ADDITIONAL TECHNICAL SPECIFICATION CHANGES
REQUESTED ON NOVEMBER 22, 1982 for R-81 LICENSE RENEWAL

ADDITIONAL ENVIRONMENTAL ASSESSMENT
INFORMATION REQUESTED 12/09/81 BY
U. S. NUCLEAR REGULATORY COMMISSION REGARDING

LICENSE NO. SNM-639 DOCKET NO. 70-687

SUBMITTED 10/21/82 BY
UNION CARBIDE CORPORATION

FIGURE 2

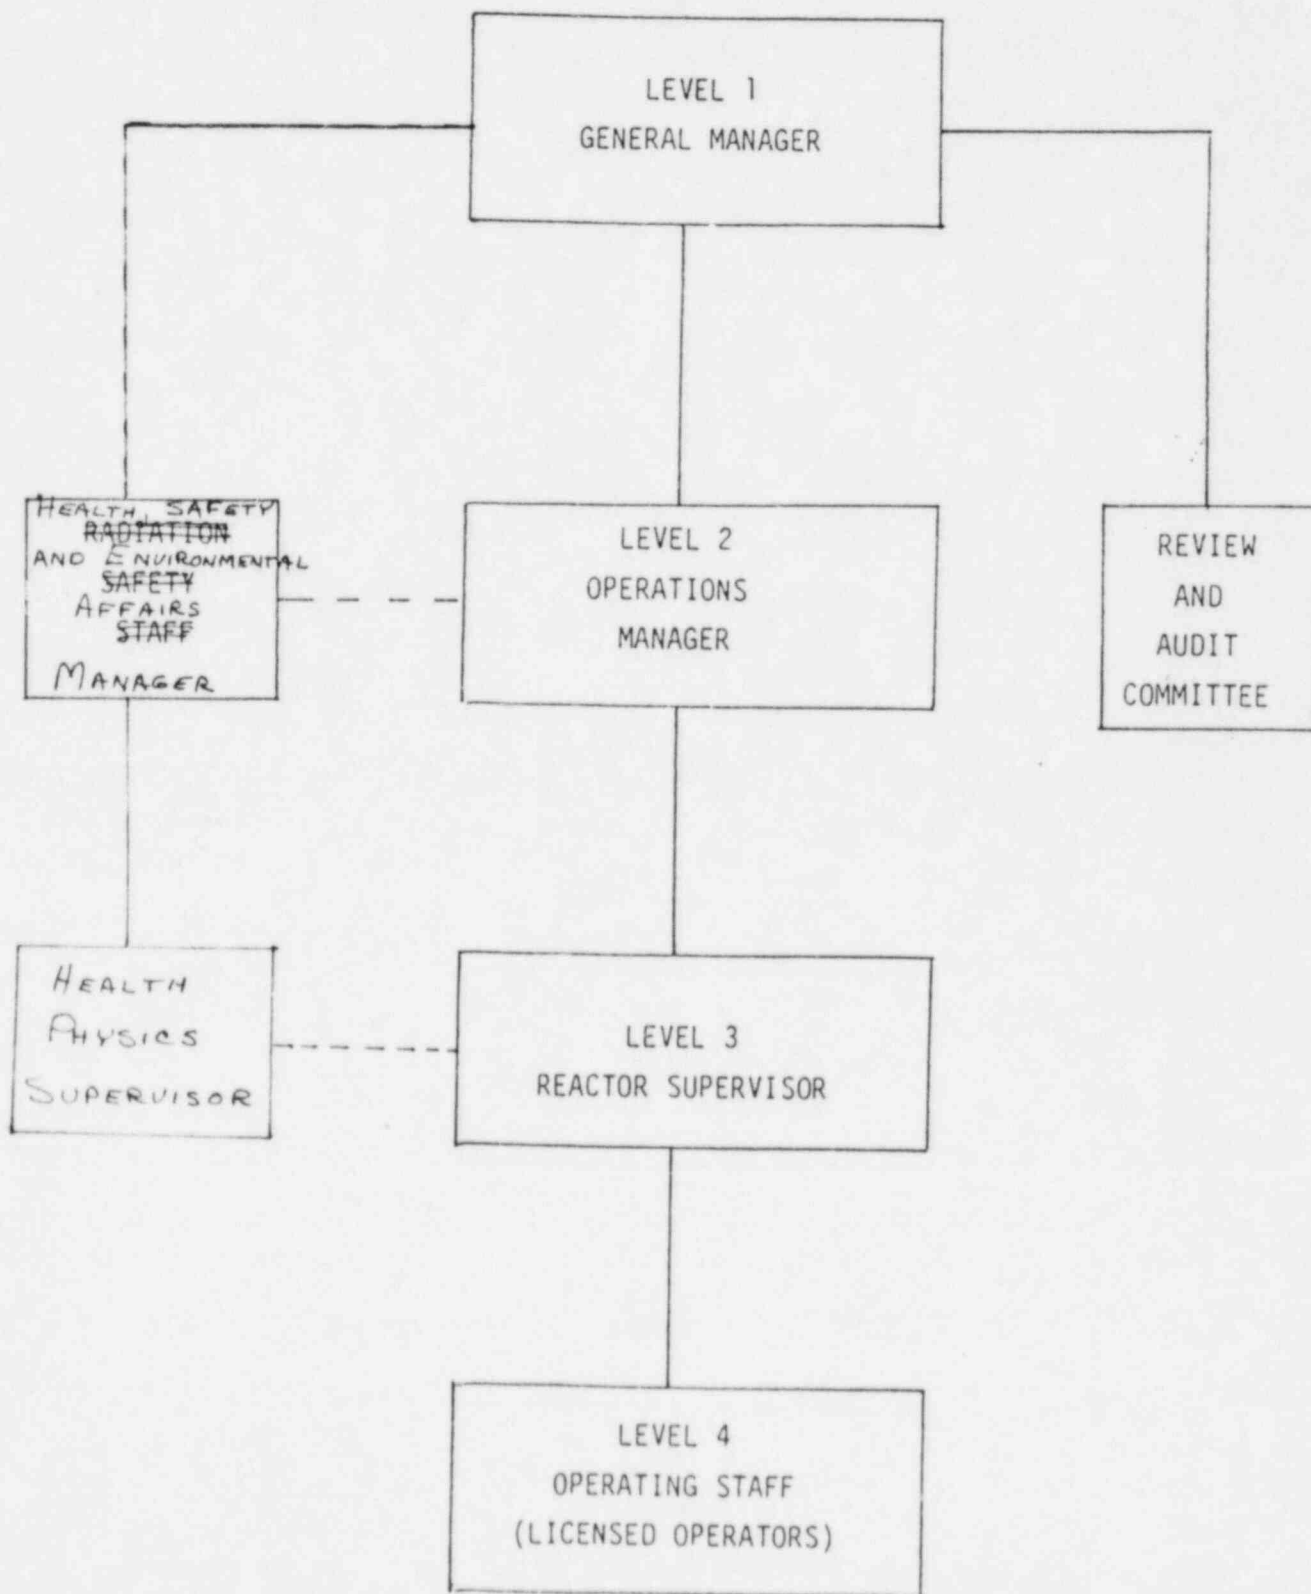
6.1.1 Structure (Administrative)

Proposed Change:

Include the radiation safety organization in the description of the organizational structure.

Reason for Change and Safety Evaluation:

The proposed change includes the duties and authority of the radiation safety staff.

The organization for the management and operation of the reactor facility shall be as a minimum the structure shown in Fig. 2. Job titles shown are for illustration and may vary. Four levels of authority are provided, as follows:

b) INDIVIDUAL RESPONSIBLE FOR THE SITE RADIATION SAFETY AND ENVIRONMENTAL AFFAIRS

b) INDIVIDUAL RESPONSIBLE FOR RADIATION PROTECTION WITHIN THE LICENSED FACILITY.

The Nuclear Safeguards Committee shall report to Level 1. Radiation safety personnel shall report to Level 2 or higher.
